PL-500165-WW

Summary Description
Mixed use development, comprising of residential units and commercial spaces and all associated ancillary site works.

Site Location
Site largely within the Former Bray Golf Course Lands , Off Ravenswell Road and Dublin Road , Bray

Comment on First Party Appeal by Shankill Property Investments:

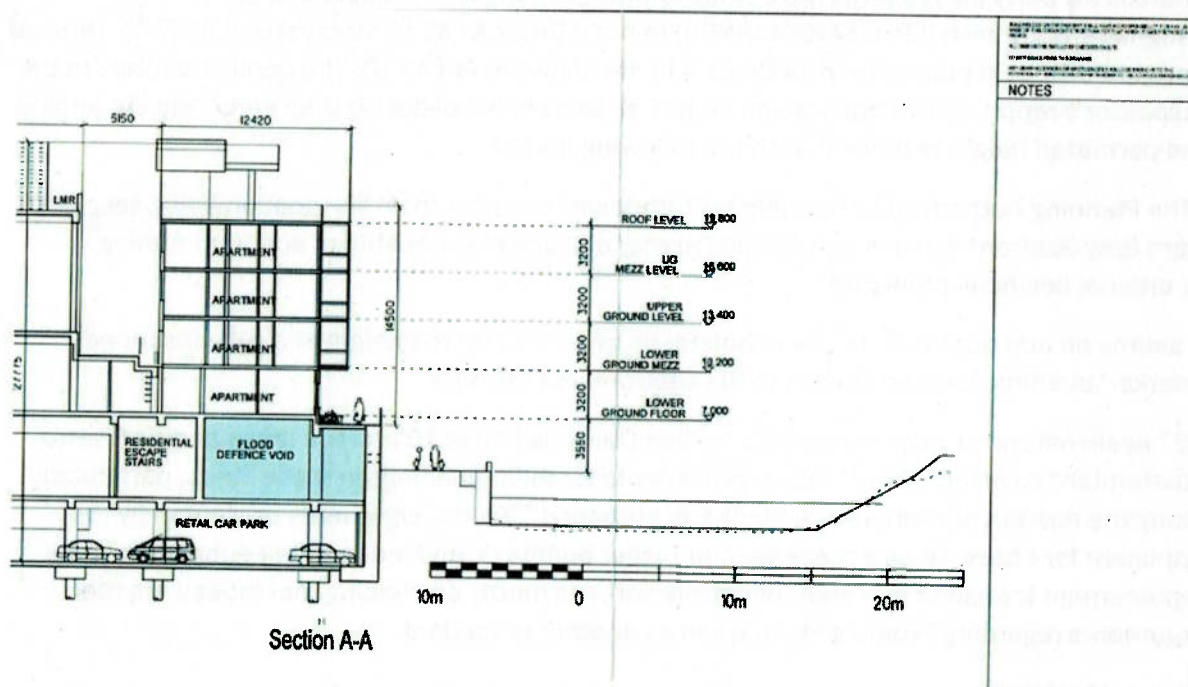
Within Wicklow's border, the main difference was a reduction of 206 parking spaces, allowing a flood defence void - a culvert approximately 8m high by 10m wide - to run through the basement car park, in theory replacing the open floodplain, where floods from upriver are stored. *This culvert is shown in the drawing below, copied from Pizarro's 2nd application.*

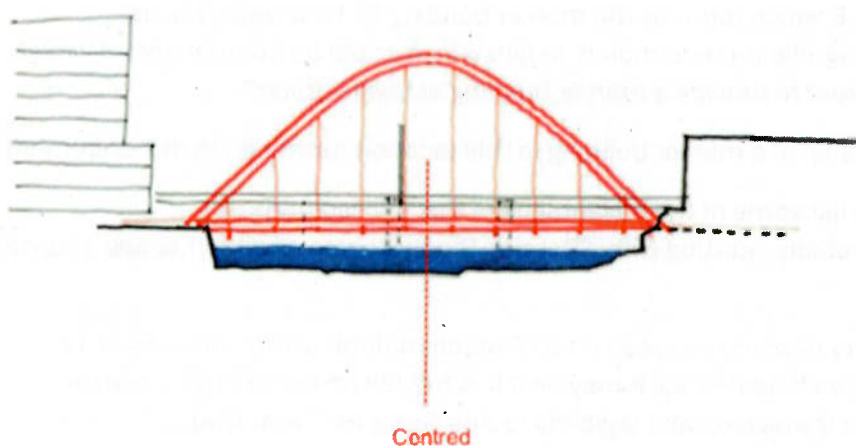
On p6 (2.1.1) of their Appeal, the applicant makes a statement that is repeated throughout their appeal to this Condition, i.e. that Block E was designed to be a marker building in this location.

Co-incidentally, on p6 (4.3) of the Architectural Design Statement for Wicklow's proposed bridge, it states: "The bridge should be a landmark "eye-catcher", as seen from the east by train travellers and from the west from the Fran O'Toole Bridge, and the river banks."

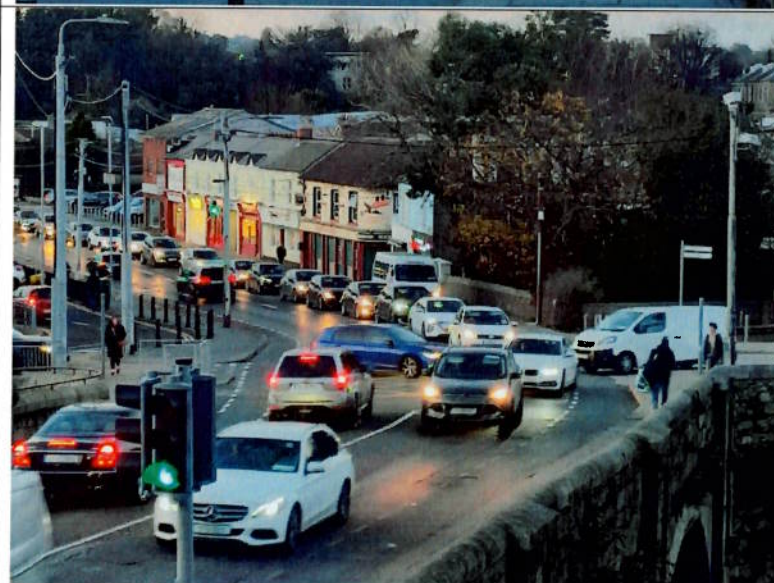
Below are photographs showing the flexible bollards several months ago, and then normal rush hour traffic on this bridge, from both directions, on 19th November:

Note road to the right, after the bridge, leading to The Maltings housing estate, which cyclists must cross. This faces the Seapoint Road, a turning already categorised as dangerous in 2008.

Traffic coming from the north into the town centre, over the Fran O'Toole bridge. On the right is Ravenswell Road, on the left is the Lower Dargle Road.

Left: Traffic from the north crossing the Fran O'Toole bridge, with the Royal Hotel above left.

The dedicated cycle and pedestrian lanes already in place on the Fran O'Toole bridge have made an already narrow bridge even narrower, and the flexible bollards in place to mark those lanes would not protect any cyclist or pedestrian in case of a vehicle bumping inadvertently into them.

Fig. 1: Former Bray Golf Club lands, 2016:

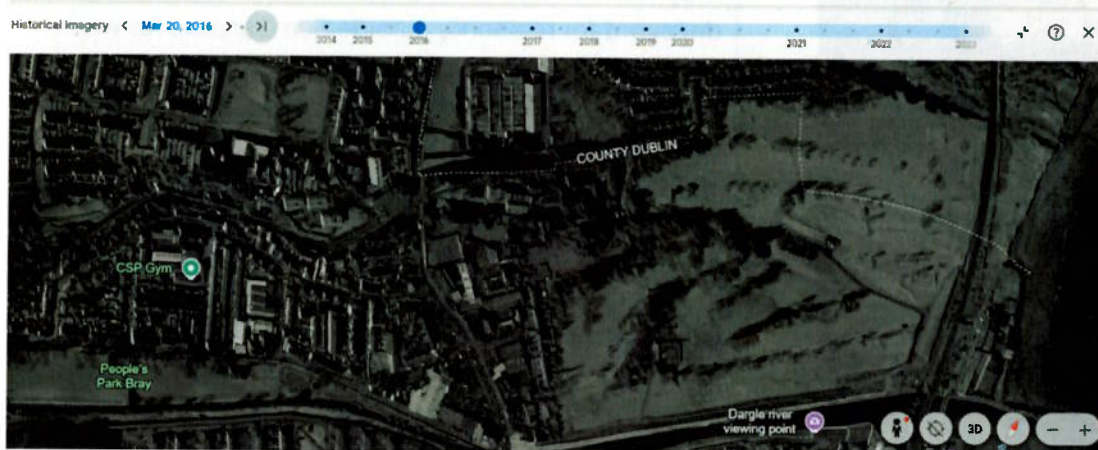
As can be seen from the three Google Earth historical maps below, most of this road was already in existence when the applicant purchased the site in December, 2019. Built for the Ravenswell School campus, it is referred to locally as the 'Schools' Road' because it was constructed to facilitate the two new schools as per Planning Application 15/190.

Work commenced on the building of St. Philomena's Primary school (Ravenswell) and Coláiste Raithín on the high ground of the former golf club lands in July, 2016. The two schools finally moved into their new premises in autumn 2018. The Google Earth maps on the following page (Figs. 1-3) show no roads at all in 2016, work in progress in 2017, and the road completed in 2018.

Fig. 3: Former Bray Golf Club lands, 2018:

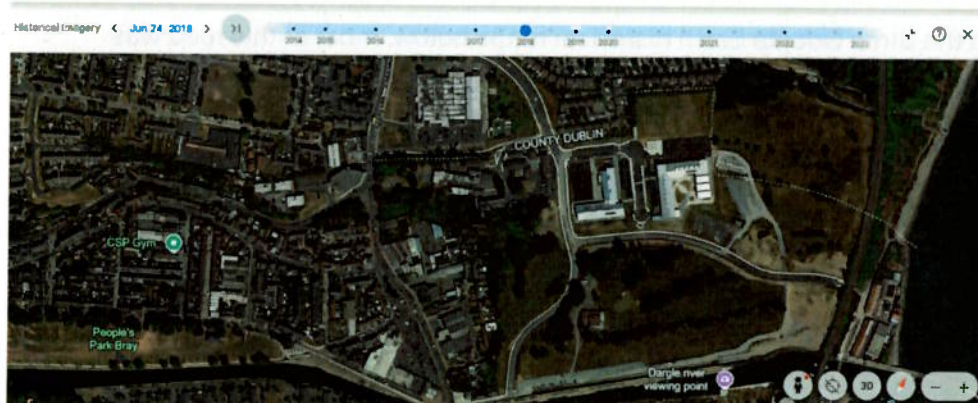
The eastern end of this road, adjoining the railway underpass, was excavated in 2023, while in the possession of Shankill Property Investments, allegedly in order to facilitate necessary public water improvements by Irish Water. However, the actual excavation of the road, and its reinstatement, were carried out by Shankill Property Investments, according to an email we have received from Irish Water, stating that it made practical sense – as the applicant was also carrying out work on the road at that time – to facilitate both. *The route of the road was changed during that reinstatement in order to facilitate Shankill Property's plans.*
